IEC/IEEE 62582-2

### AMENDMENT 1

**Nuclear power plants – Instrumentation and control important to safety –  
Electrical equipment condition monitoring methods –  
Part 2: Indenter modulus**

**Figure 1 – Geometry and dimensions of the profile of the probe tip (truncated cone) used in the indenter**

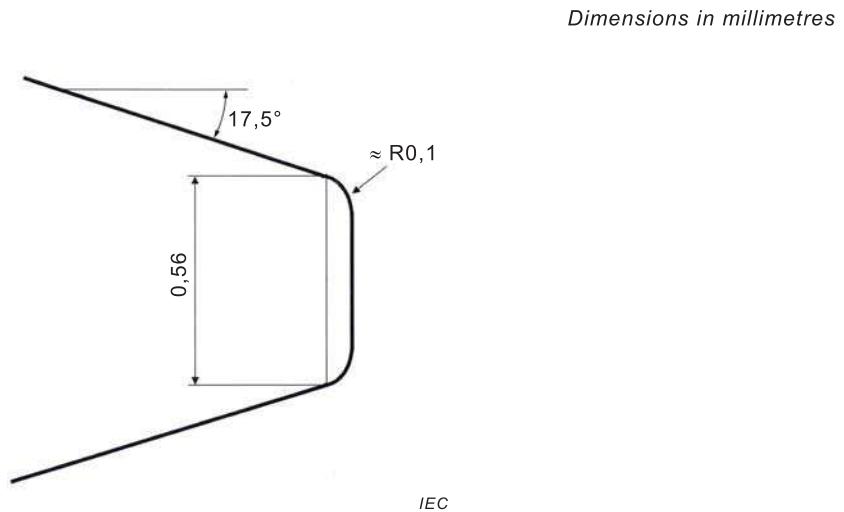
Replace existing Figure 1 by the following new Figure 1:

**Figure 2 – Calculation of indenter modulus**

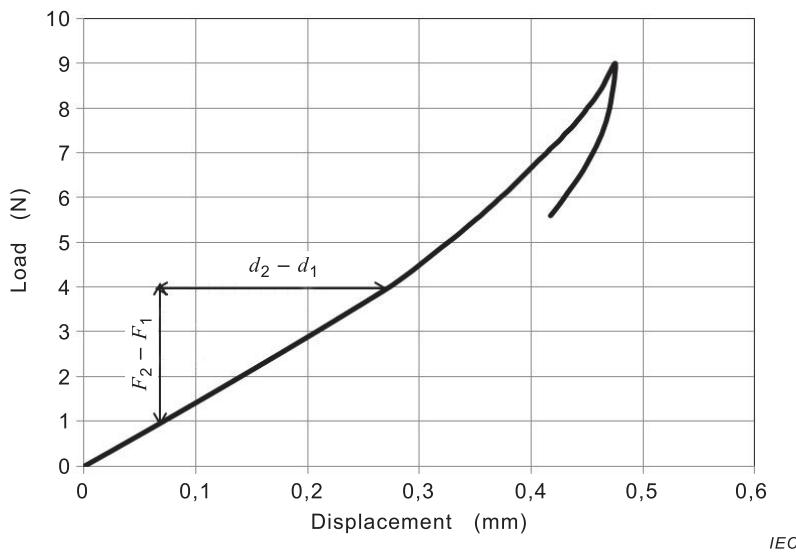
Replace existing Figure 2 by the following new Figure 2 and add a note after Figure 2 as follows:

NOTE Some instruments used for indenter measurements show the result in load versus time (in  $\text{N}\cdot\text{s}^{-1}$ ). The value of the indenter modulus in  $\text{N}\cdot\text{mm}^{-1}$  is then calculated as the value in  $\text{N}\cdot\text{s}^{-1}$  divided by the probe velocity in  $\text{mm}\cdot\text{s}^{-1}$ .

**Figure A.1 – Example of local variation of indenter modulus due to variation in equipment dimensions and construction**

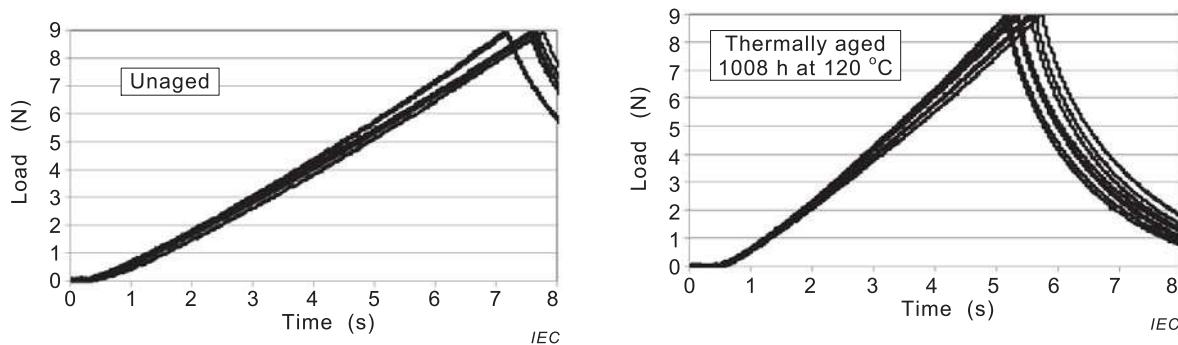
Replace existing Figure A.1 by the following new Figure A.1:

NOTE The probe velocity was  $5,2 \text{ mm}\cdot\text{min}^{-1}$  and the indenter modulus values were calculated from the slope between 1 N and 4 N by division by  $5,2\cdot60^{-1}$ .

**Figure B.1 – Example of measured force versus time**

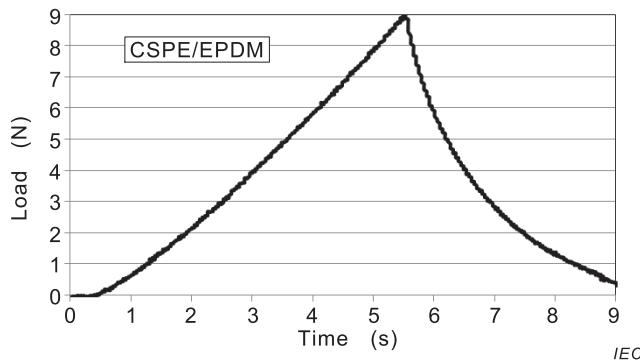
Replace existing Figure B.1 by the following new Figure B.1:

NOTE The indenter modulus value was calculated from the slope between 1 N and 4 N by division by  $5,162\cdot60^{-1}$ .

**Figure 1 – Géométrie et dimensions correspondant au profil de l'extrémité de la sonde (cône tronqué) utilisée pour le poinçonnement**

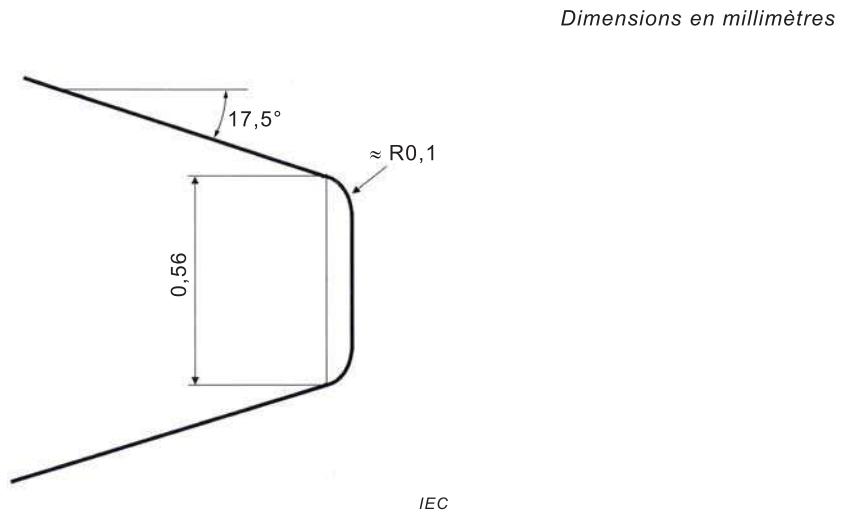
Remplacer la Figure 1 existante par la nouvelle Figure 1 suivante:

**Figure 2 – Calcul du module indenter**

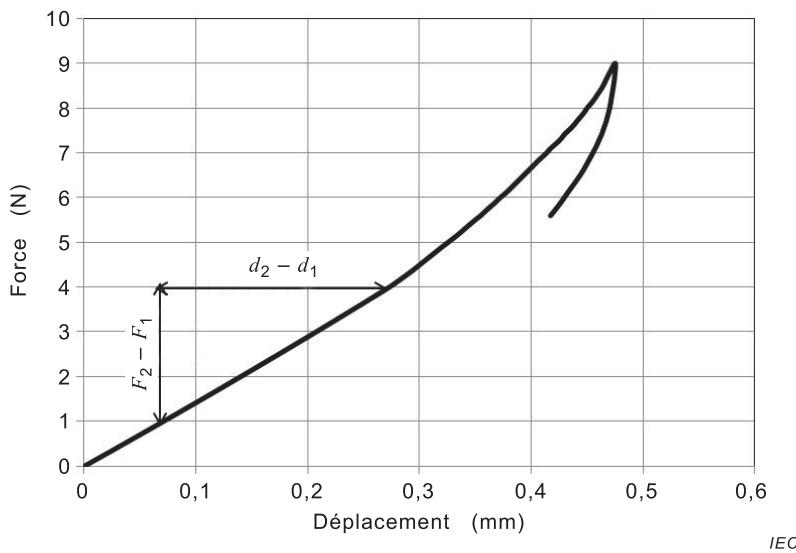
Remplacer la Figure 2 existante par la nouvelle Figure 2 suivante et ajouter une note après la Figure 2 comme suit:

NOTE Certains appareils utilisés pour les mesures indenter indiquent la valeur de la force en fonction du temps (exprimée en  $\text{N}\cdot\text{s}^{-1}$ ). La valeur du module indenter exprimée en  $\text{N}\cdot\text{mm}^{-1}$  est alors calculée comme la valeur exprimée en  $\text{N}\cdot\text{s}^{-1}$  divisée par la vitesse de la sonde en  $\text{mm}\cdot\text{s}^{-1}$ .

**Figure A.1 – Exemple de variation locale de la valeur du module indenter due à la variation de dimension et de construction de l'équipement**

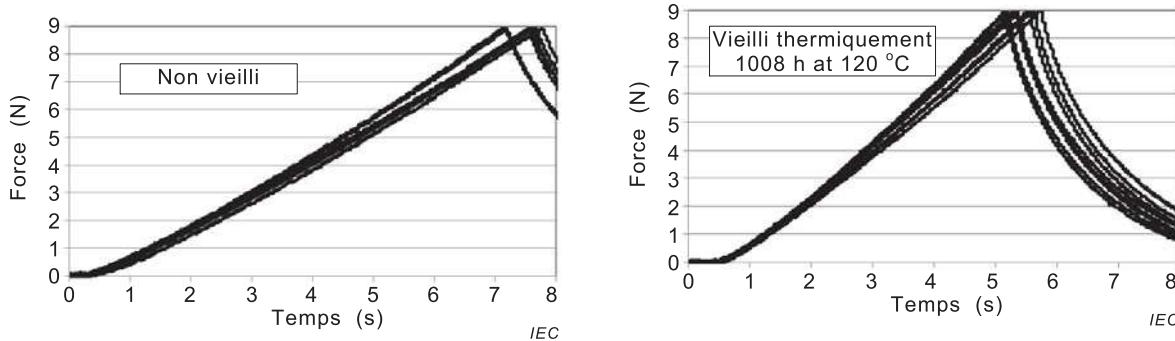
Remplacer la Figure A.1 existante par la nouvelle Figure A.1 suivante:

NOTE La vitesse de la sonde était de  $5,2 \text{ mm} \cdot \text{min}^{-1}$  et les valeurs du module indenter ont été calculées entre 1 N et 4 N en divisant par  $5,2 \cdot 60^{-1}$ .

**Figure B.1 – Exemple de la force mesurée en fonction du temps**

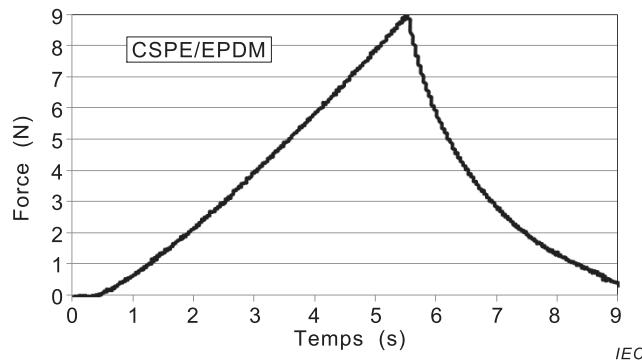
Remplacer la Figure B.1 existante par la nouvelle Figure B.1 suivante:

NOTE La valeur du module indenter a été calculée en prenant la pente entre 1 N et 4 N et en divisant par  $5,162 \cdot 60^{-1}$ .
